Cowlitz Indian Tribe

November 28, 2016

RE: Comments Regarding the Draft Environmental Impact Statement (Draft EIS) Concerning the Proposed Millennium Bulk Terminals-Longview.

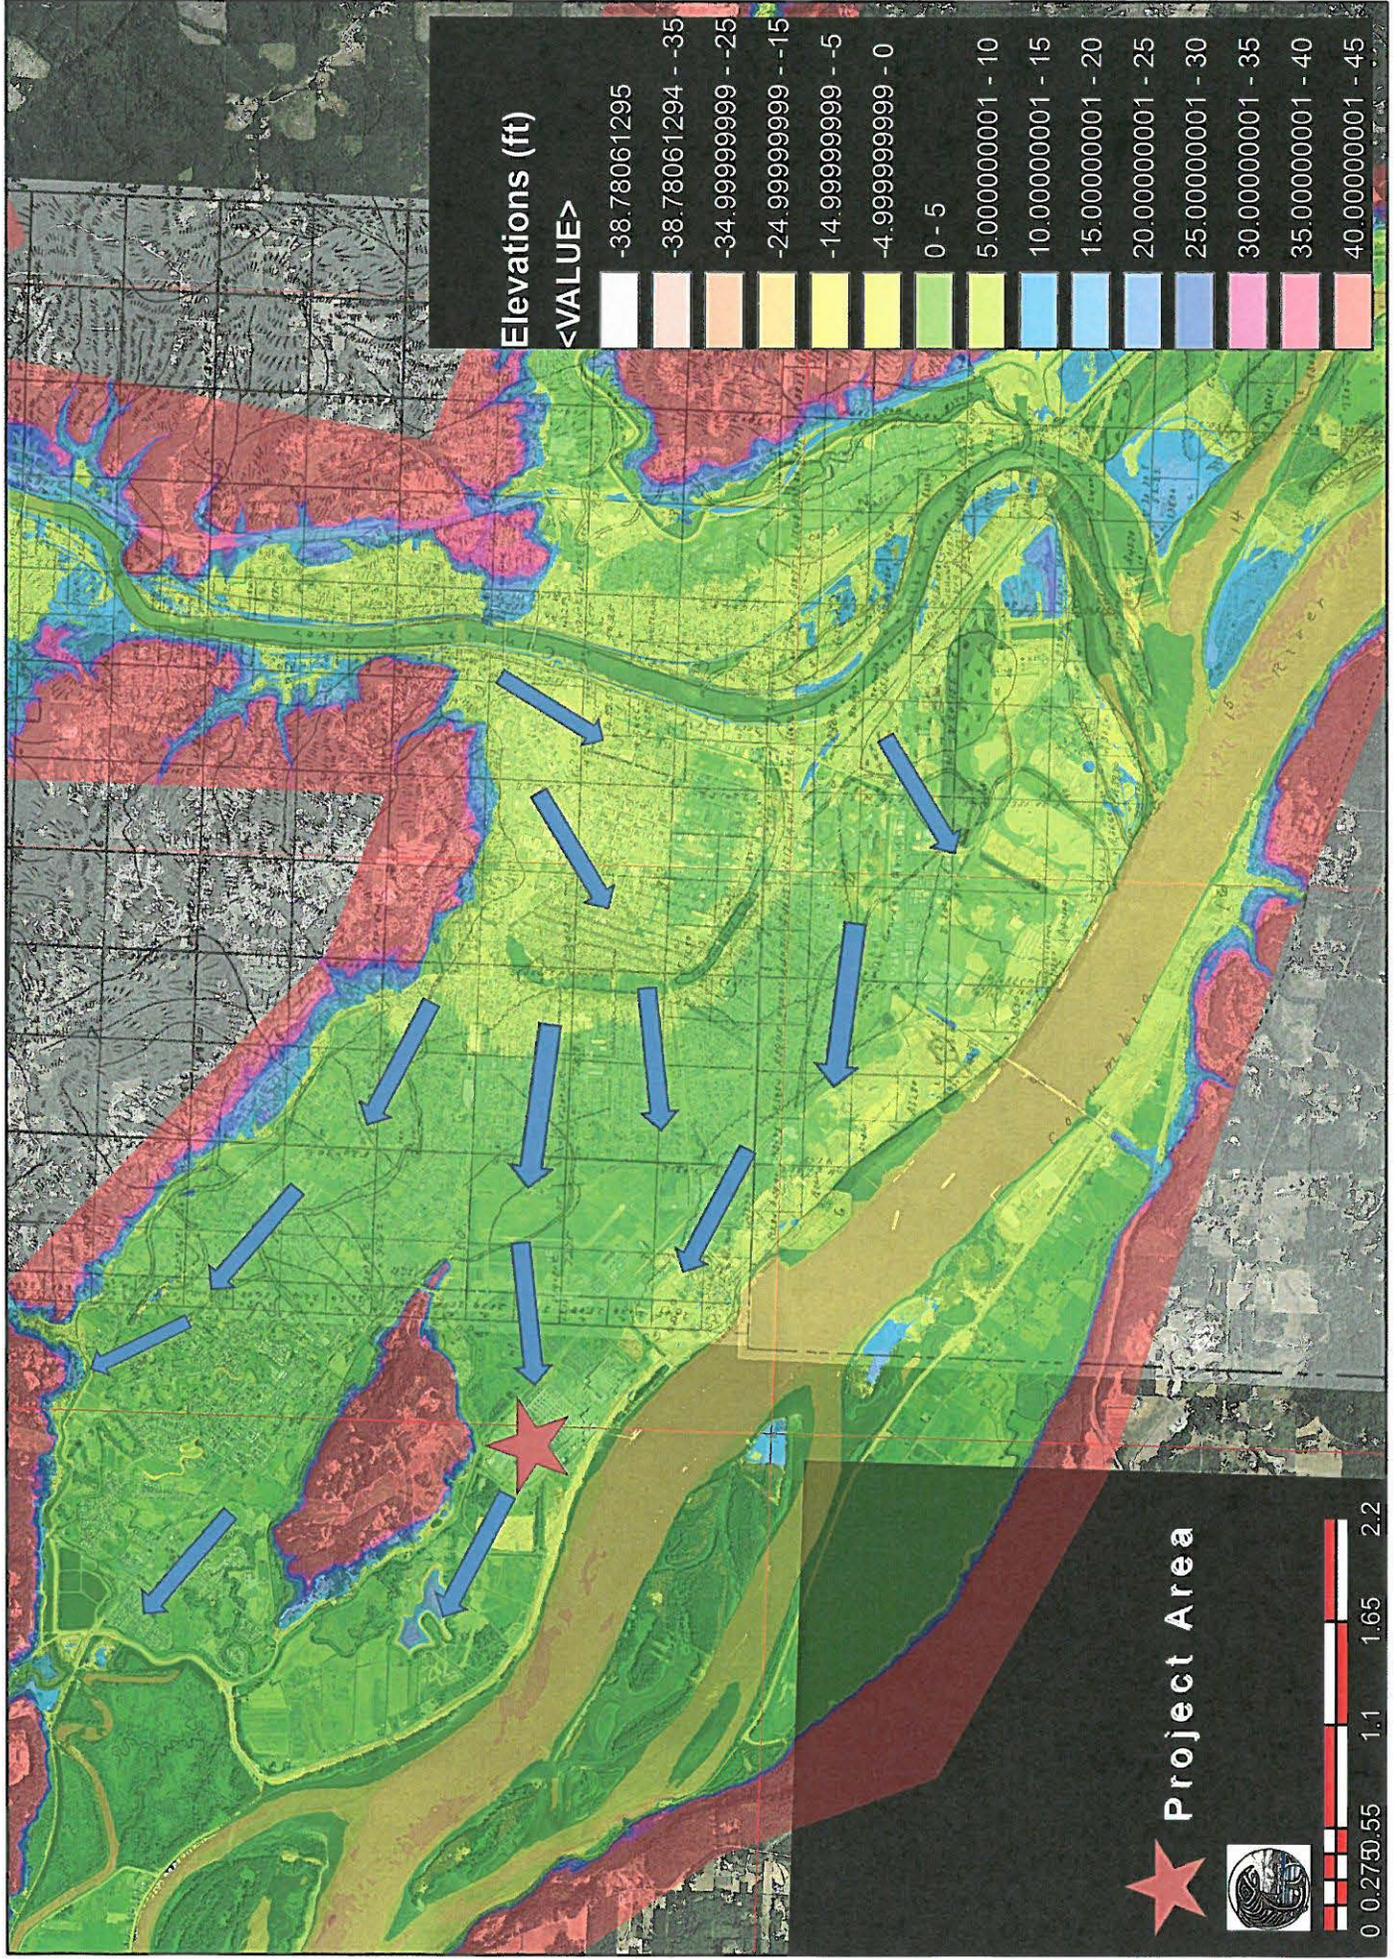
Floodplain elevation data was analyzed by the Cowlitz Indian Tribe. The DEIS identifies the project elevation, in general, at 16 feet above sea level (no datum supplied). Elevation data at the project site generally ranges from 5 feet to 11 feet elevation with only the elevated regions near the levee and the closed landfill reaching 16 feet. At this location, 13 feet is major flood stage. Most of the project area elevation is within the 100 year floodplain.

The Columbia River has a historically recorded crest of 24'. More frequently, the river crests between 14 and 18 feet. However, because we don't have a datum, it is impossible to determine the exact correlations between the project area elevation and river surface elevations.

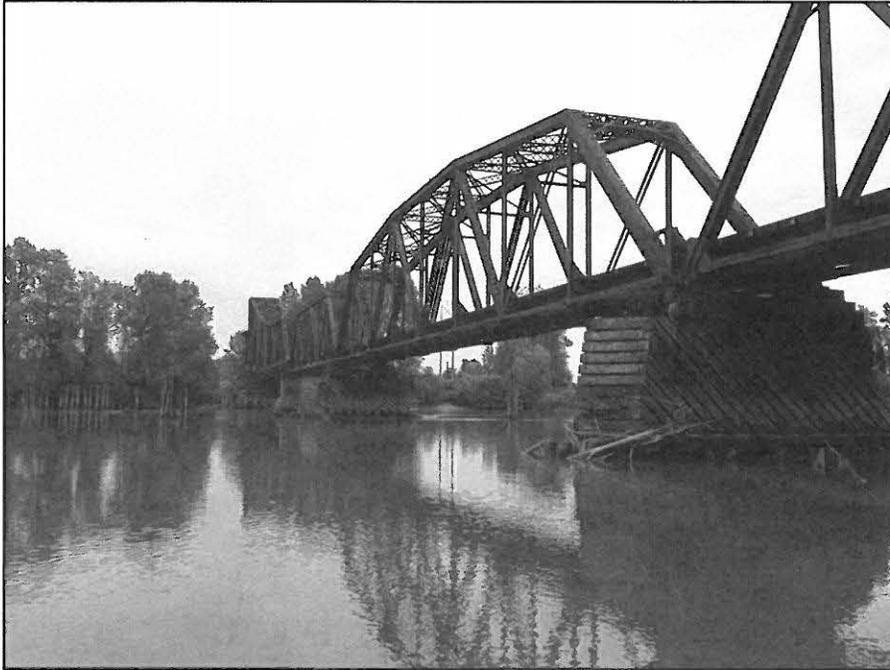
The DEIS does not describe at any point that the "350 loaded trains of 100 cars each, and 350 empty trains of 100 cars each" would cross the Cowlitz Rail Bridge in Kelso, WA. By the way, 350 loaded trains represents 43 days of work. An annual estimate of incoming trains would actually be 2,920 through the Longview industrial area and crossing several local and state roadways.

We believe that there is enough concern currently to close industrial rail traffic across the BNSF - Cowlitz River Railroad Bridge. We don't believe that it is designed or intended to handle the Proposed Action's volume of rail traffic in either the short or long-term. We believe that this is a disaster waiting to happen, given that much current public and policy concerns regarding rail safety have been expressed through a variety of media.
